COMMENT AND RESPONSE DOCUMENT

Regarding Adoption of Air Quality Regulations Concerning Nitrogen Oxides (NOx) emissions

Date of Hearing: June 8, 2016

Figure 1-Relative contribution of source emissions to Fairfield, CT ozone monitor

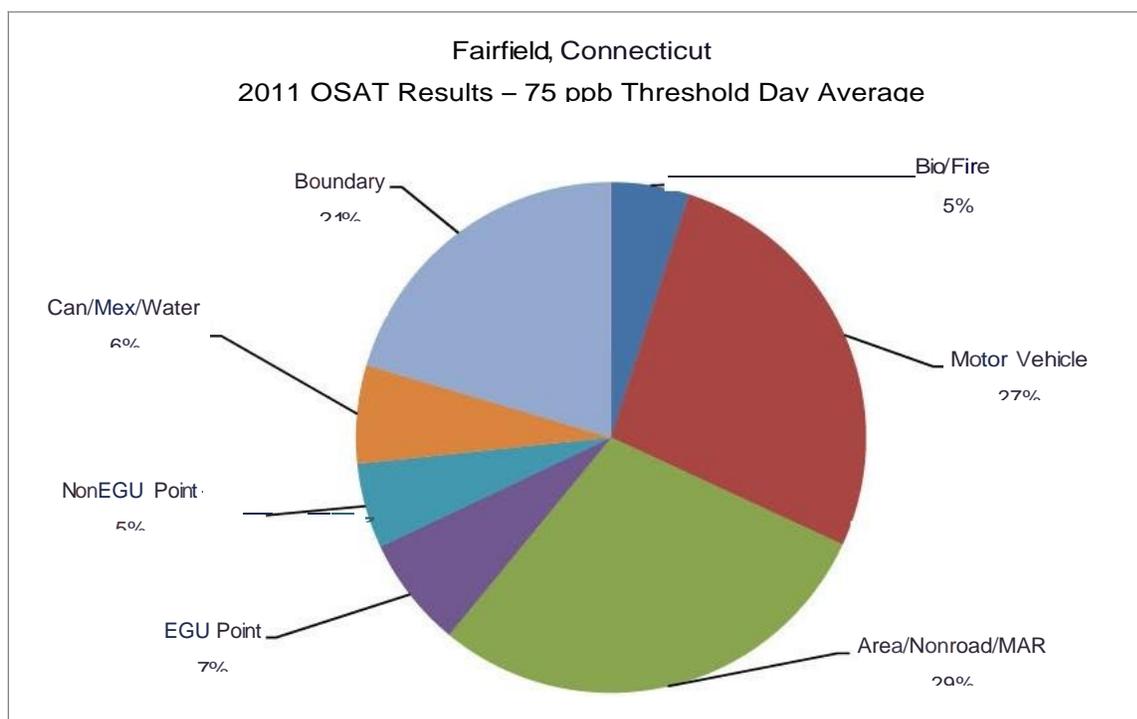
The commenter’s regional modeling analysis, conducted by Alpine Geophysics⁷ in June 2016 and summarized in Figure 1 reveals that ratcheting down the allowable emissions, up to and including forcing full shutdown of all of NRG’s EGUs, would have very little effect on overall air quality in Connecticut. The general basis for the analysis performed by Alpine Geophysics could be expanded to other EGUs in evaluating the overall actual impact that compliance with the new RCSA section 22a-174-22e would have.

As the Alpine Geophysics modeling report demonstrates, there would be very little impact made by prescriptive emission reductions aimed at the EGUs. Based upon this analysis and the fact that forced emission reductions do not actually result in an overall improvement in air quality, there is also a significant downside to this regulation as proposed which should be taken into consideration. A few examples of the potential negative impacts that the new Section 22e could have are:

DEEP agrees that transported air pollution continues to have a significant impact on Connecticut's air quality. However, Connecticut is required by sections 182(a) and (b) and 184(b) of the CAA to adopt and update RACT-based emissions limitations for all major sources of NO_x with the promulgation of a revised ozone NAAQS. *There is no emission reduction or ozone concentration reduction requirement associated with the implementation of RACT.* Connecticut's current RACT emissions limitations in RCSA section 22a-174-22 have been in place for over 20 years. New Jersey revised its NO_x RACT regulations in 2009 and NY revised its NO_x RACT regulations in 2010 in order to address the RACT requirement for the 2008 ozone National Ambient Air Quality Standard (NAAQS). Connecticut lags behind the other states with which it shares a moderate nonattainment area under the 2008 ozone NAAQS (the result of a June 2016 "bump-up" in nonattainment classification by EPA¹⁰) in terms of updating NO_x RACT requirements, and a number of the emission limitations, including those set out for EGU boilers in RCSA section 22a-174-22, no longer represent a RACT level of control.

Figure 2 - July 11, 2011 CEM NOx emission comparison by contributing State (with NRG CT breakout).

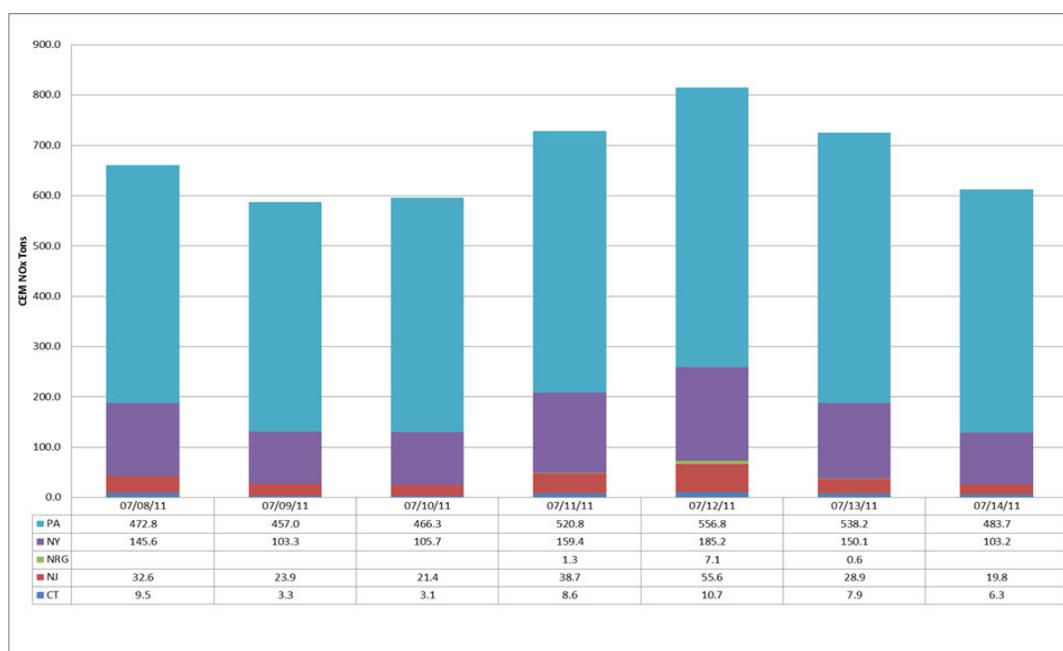
Additionally, in support of this, as can be seen in Figure 2 and from the Alpine Geophysics modeling analysis²⁰, the seasonal and HEDD daily impacts from NRG EGUs to Connecticut monitors are insignificant. Even if we were to remove all the EGUs emissions from the system there would be no impact on the state's ozone attainment status. Therefore, NRG believes that potential hours should be replaced with actual hours in the case-by-case RACT determination.

As stated in DEEP's Response to Written Comment 37, NRG, should NRG wish to apply for a case-by-case RACT determination for an emission unit, NRG may indeed use the historical actual emissions, if NRG is willing to accept an enforceable restriction on emissions for such
